737

Service Bulletin

Number: 737-28A1206
Original Issue: January 11, 2006
Revision 2: May 21, 2009
ATA System: 2822 3152

SUBJECT: FUEL - Distribution - Center Fuel Tank Boost Pump Auto Shutoff and Master Caution Logic Change

FIGURE 44: W2218 WIRE BUNDLE ROUTING

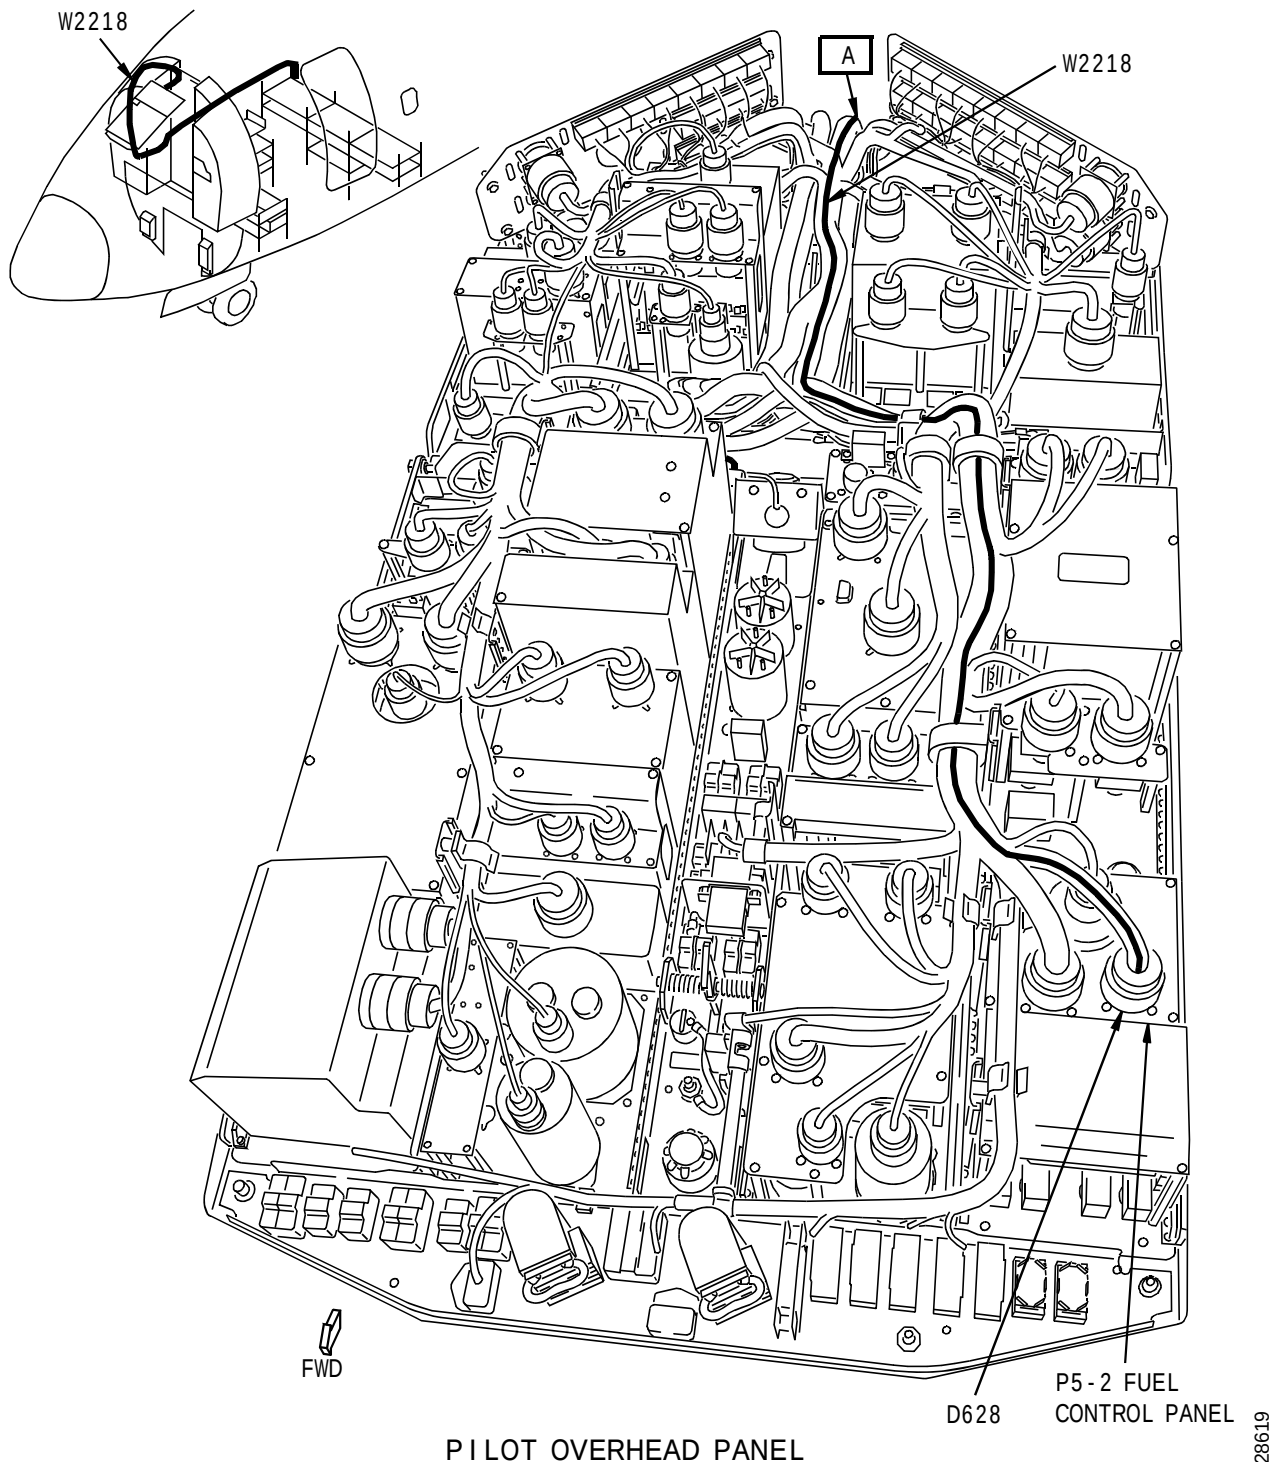
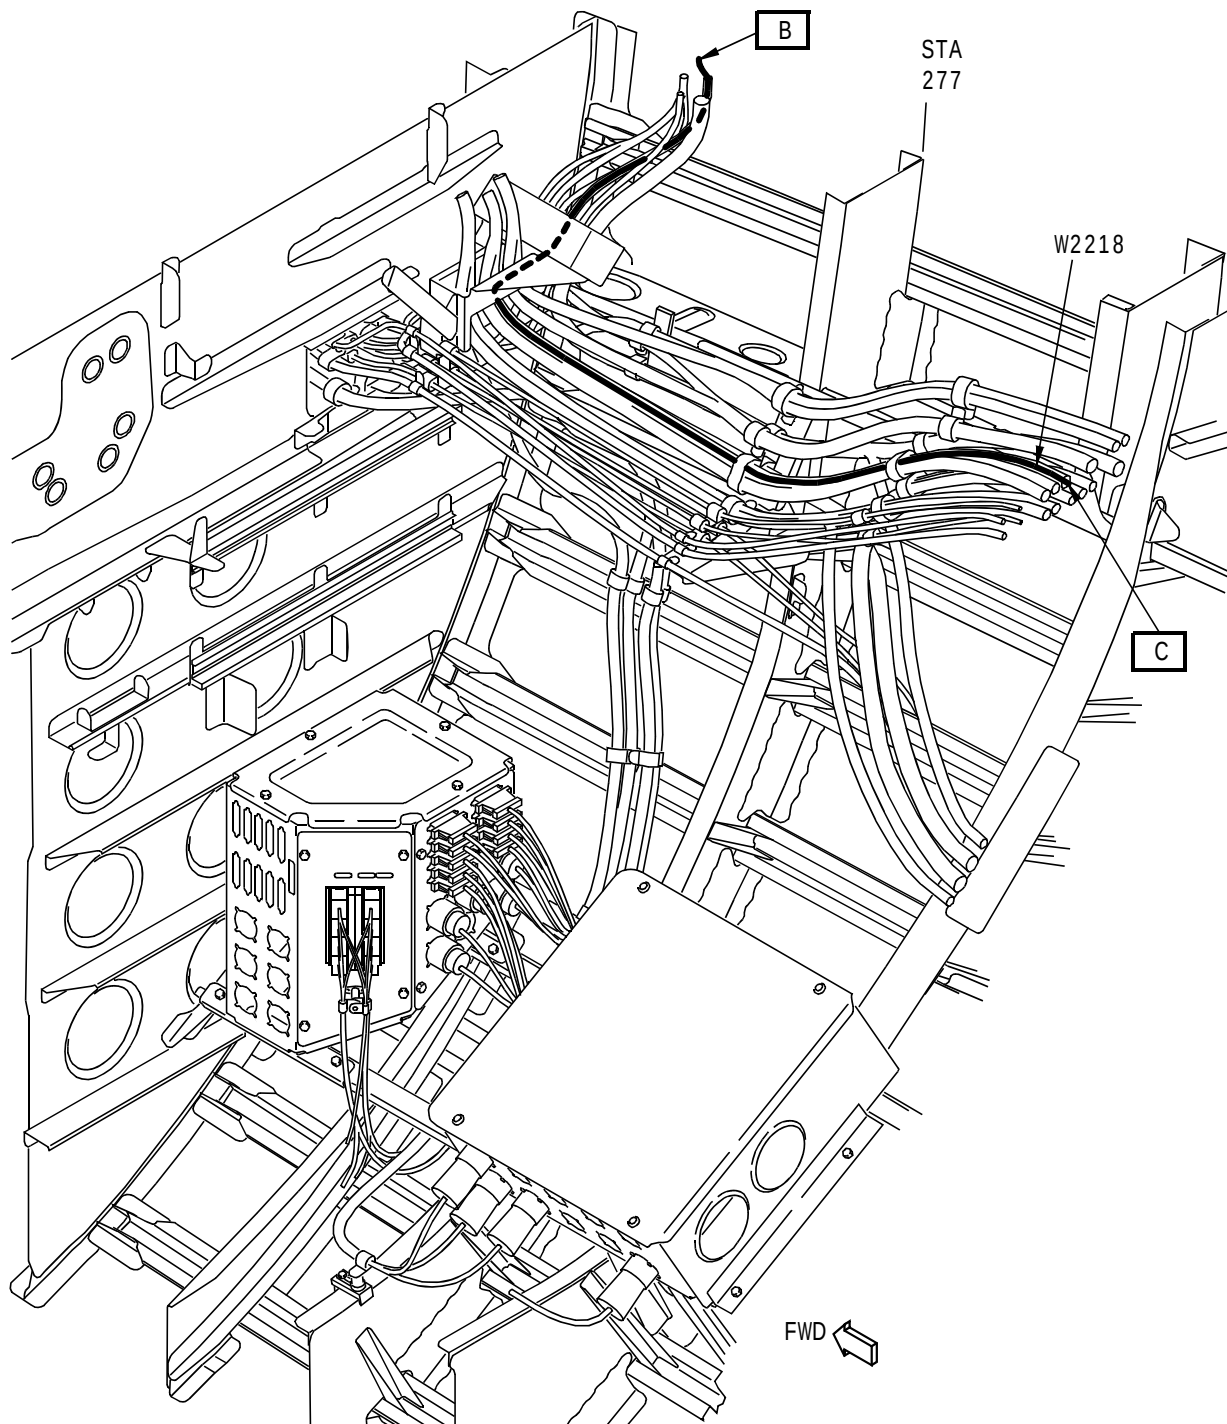
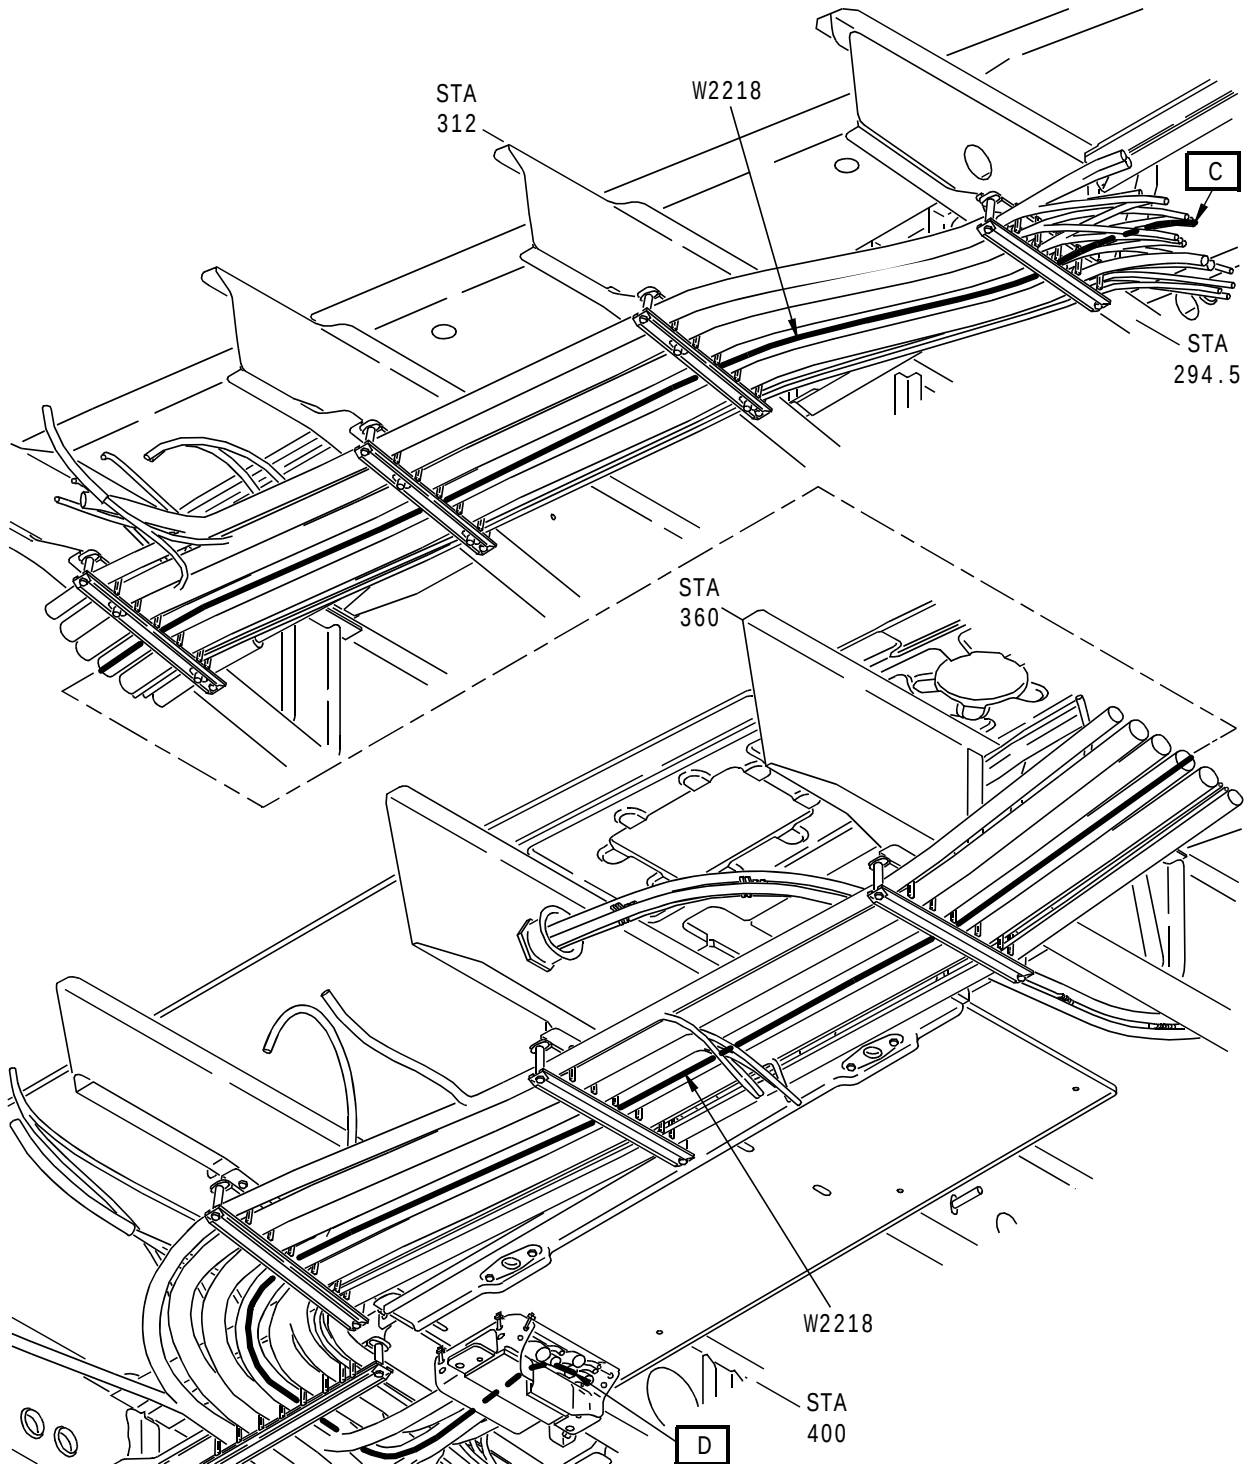
Changes are made to Figure 44 to correct the route of wire bundle W2218 and to add a title to the Figure to clarify the location shown.

FIGURE 50: WIRE BUNDLE W5160 WIRING CHANGE

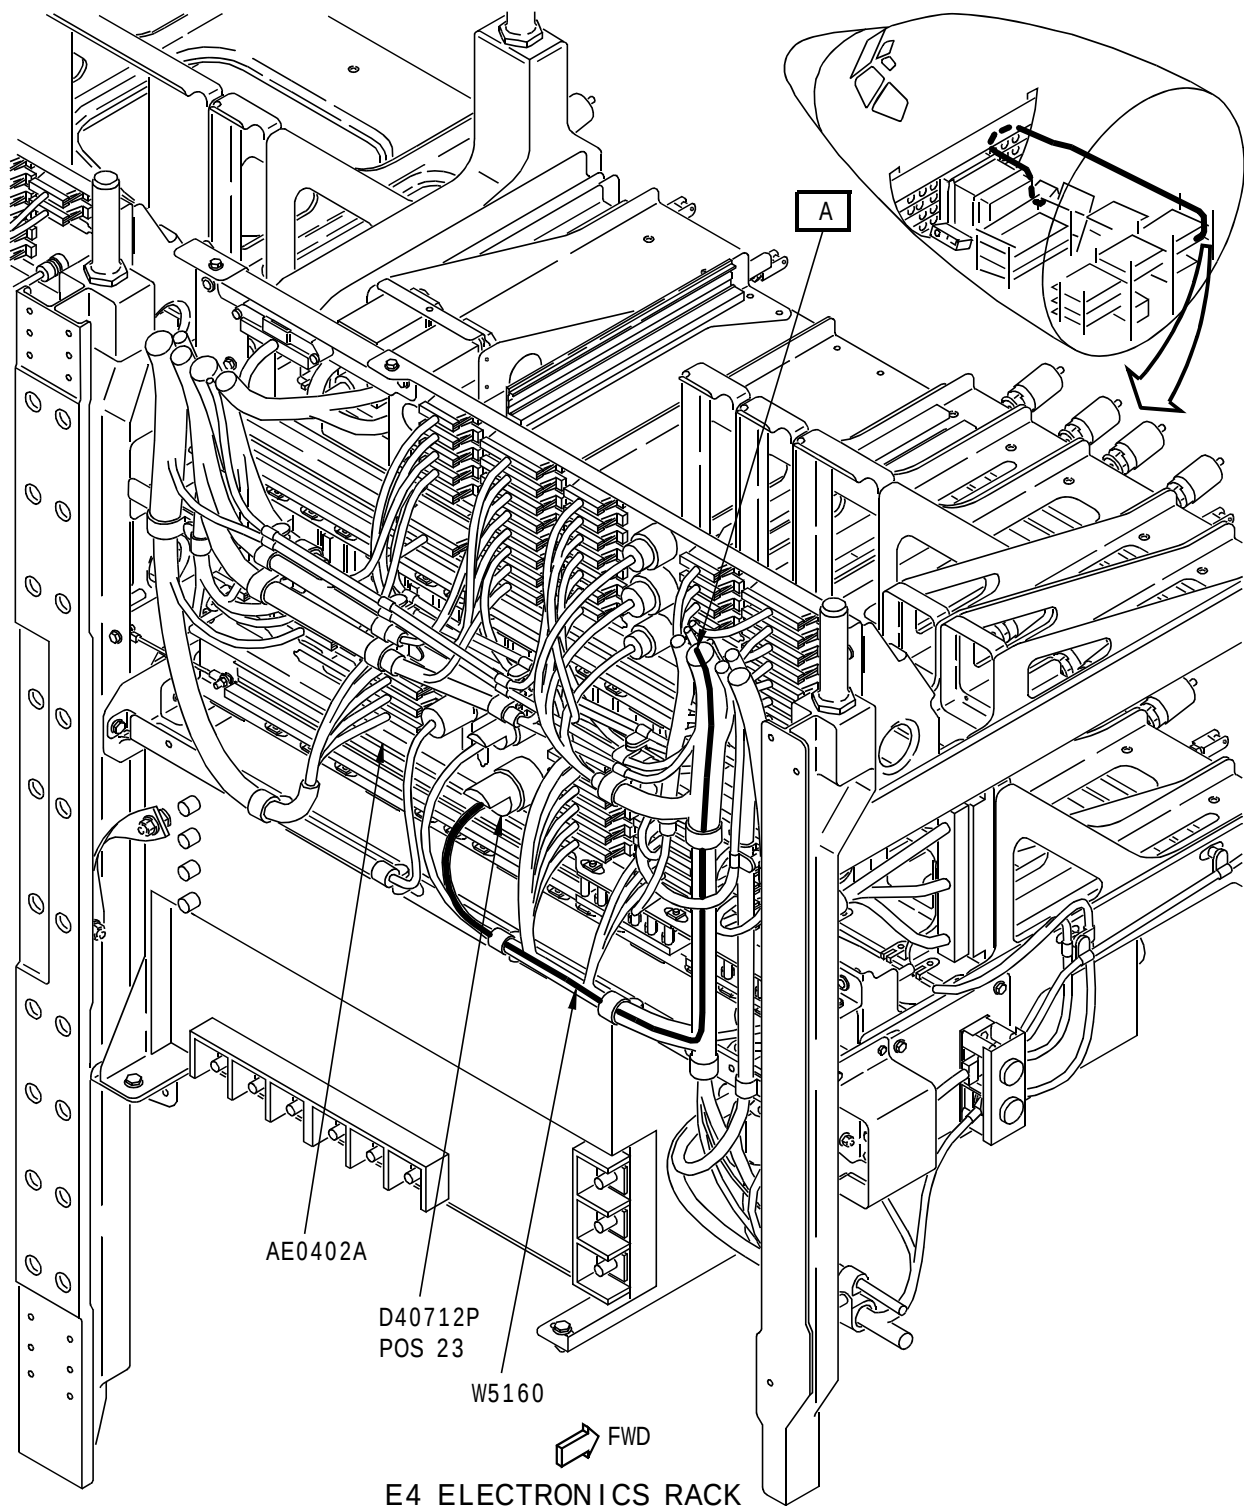
Changes are made to Figure 50 to change Socket Contact part number BACC47CP1A to BACC47CP1S and to change Pin Contact part number from BACC47CN1A to BACC47CN1SB.

FIGURE 53: CONNECTOR RELOCATION ON J4 JUNCTION BOX - WIRE BUNDLES W0094, W5160, W5520, AND W6222 ROUTING

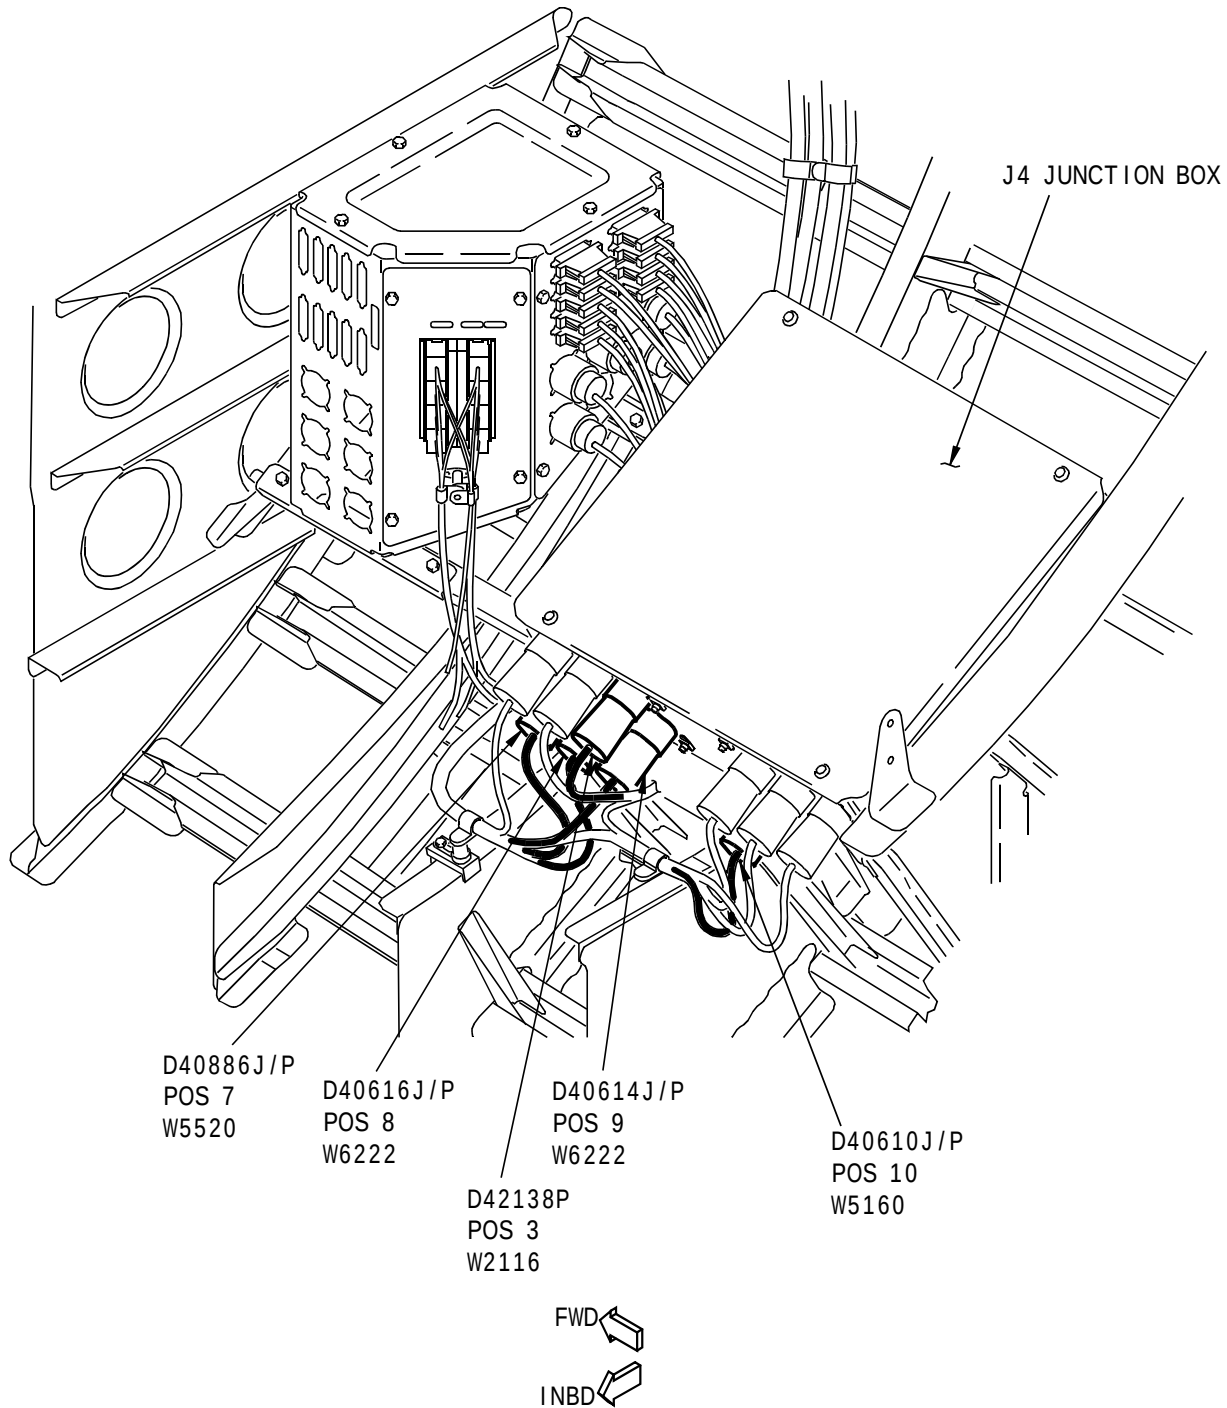
Changes are made to Figure 53 to remove the step table.

FIGURE 55: J4 JUNCTION BOX RELAY INSTALLATION

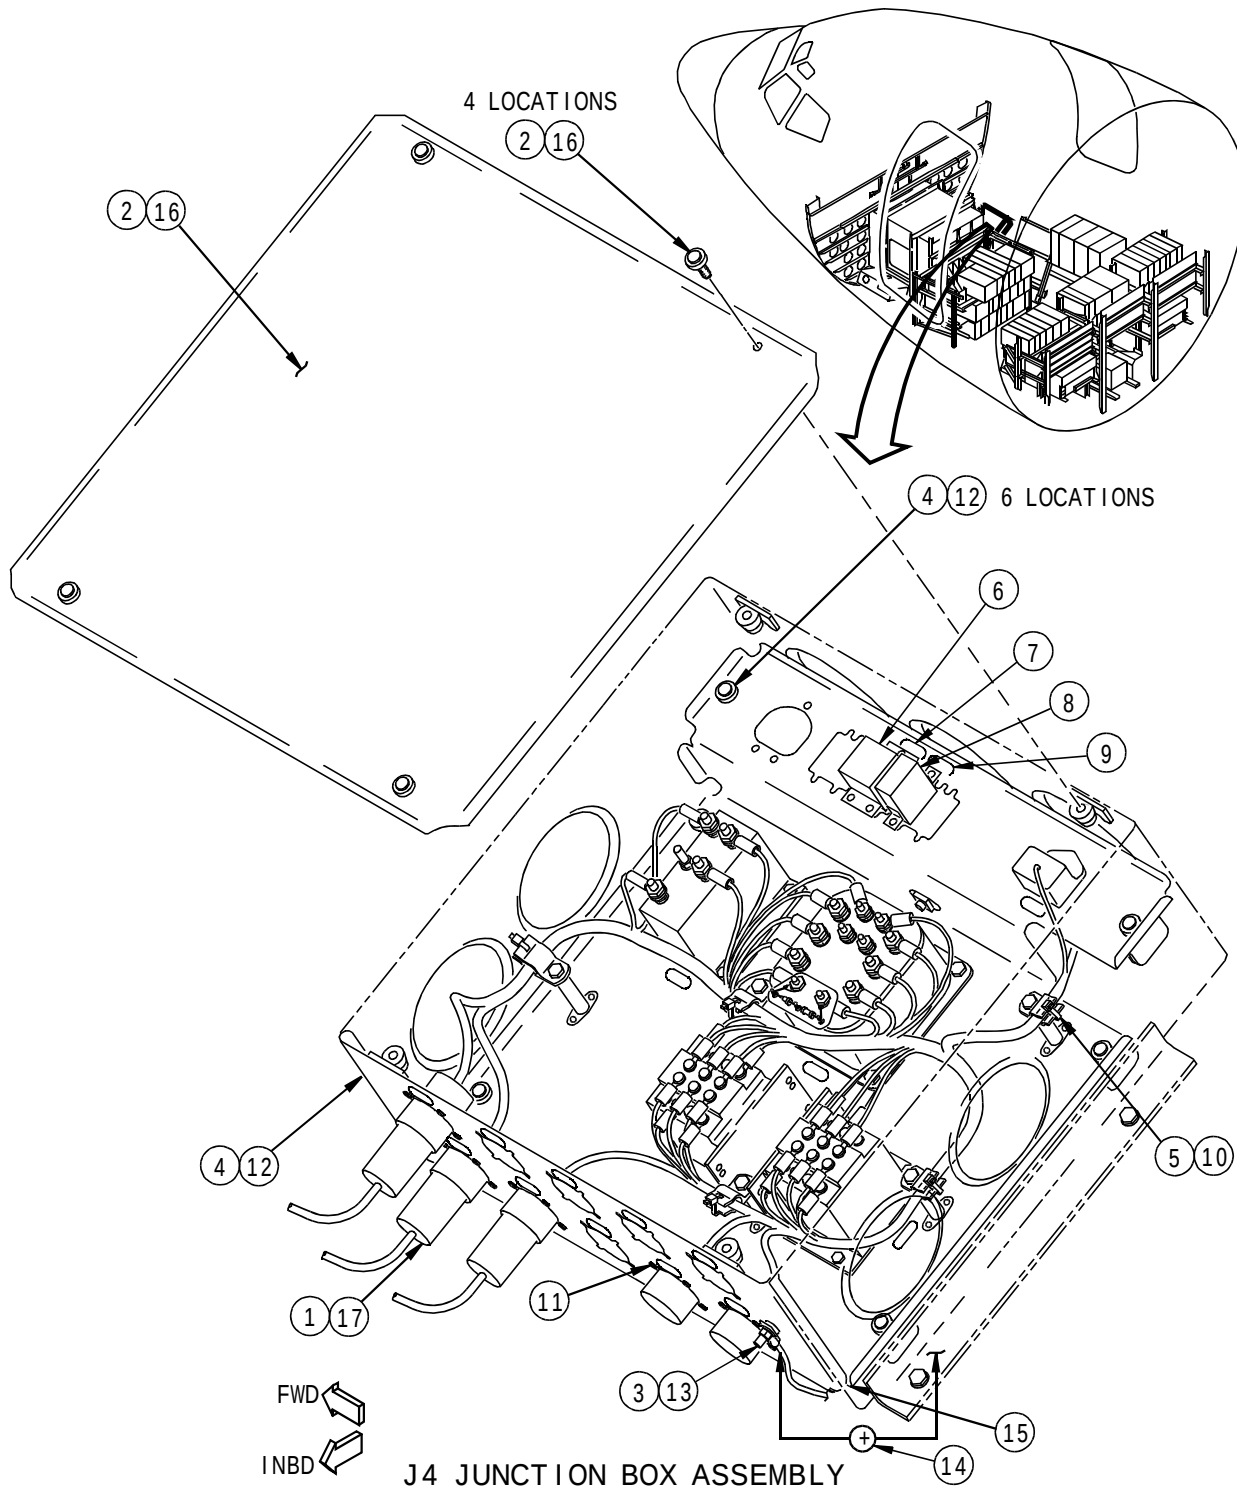
Figure 55- Changes are made to add an existing J4 Junction Box part number 284A1204-116 that was missing from previous revision, and to add the new J4 Junction Box part number 284A9200-135 that has to be marked on the re-worked J4 Junction Box 284A1204-116.
